Access Compliance Report

Public Rights-of-Way

(Curb Ramps)

Intersection ID: 52630	Main Street: WEYMOUTH_LN	Cross Street: ALEXANDER_DOWD_DR	Location:	N
ADA ID: 0E6F4B30C177	Ramp Type: Perp	Initial Pass/Fail: Pass	Overall Compliance: No	Severity Score: 2.75
Codes/Mitigation Info/Possible Solution		Field Measurements/Component Compliance

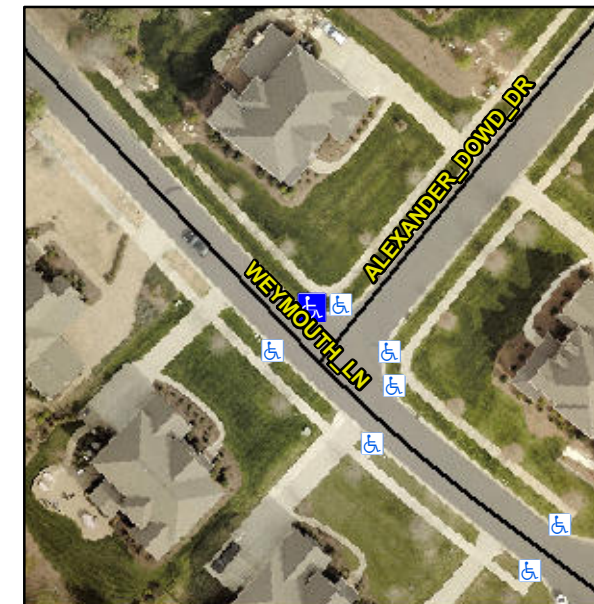
R304.5.3, R305.1.4

Compliance	Description	Data	Compliance	Description	Data
N/A	Ramp Length (in)	96.0	Yes	Ramp Slope (%)	6.6
Yes	Ramp Width (in)	60.0	No	Ramp XSlope (%)	3.9
N/A	Flare Type LT	Sloped	N/A	Flare Type RT	N/A
N/A	Flare Slope LT (%)	14.0	N/A	Flare Slope RT (%)	11.2
N/A	Flare Traversable LT?	No	N/A	Flare Traversable RT?	No
Yes	Landing Length (in)	61.0	Yes	DWS Provided?	Yes
Yes	Landing Width (in)	60.0	Yes	DWS Contrast?	Yes
Yes	Landing Slope (%)	2.0	Yes	DWS Length (in)	24.0
No	Landing X Slope (%)	2.5	No	DWS Full Width?	No
N/A	Landing Curb? (Y/N)	No	Yes	DWS Offset (in)	1.0
N/A	Shared Landing?	No			
Yes	Gutter Ponding?	No	Yes	Gutter Slope (%)	3.1
Yes	Gutter Lip Ht (in)	0.0	Yes	Gutter X Slope (%)	1.1
N/A	Painted X Walk1?	No	N/A	Painted X Walk2?	N/A
	X Walk 1 Direction	To SW		X Walk 2 Direction	N/A
N/A	X Walk 1 Width (in)	N/A	N/A	X Walk 2 Width (in)	N/A
	X Walk 1 Slope (%)	0.5		X Walk 2 Slope (%)	N/A
	X Walk 1 X Slope (%)	0.9		X Walk 2 X Slope (%)	N/A

Remove & Replace Entire Ramp.
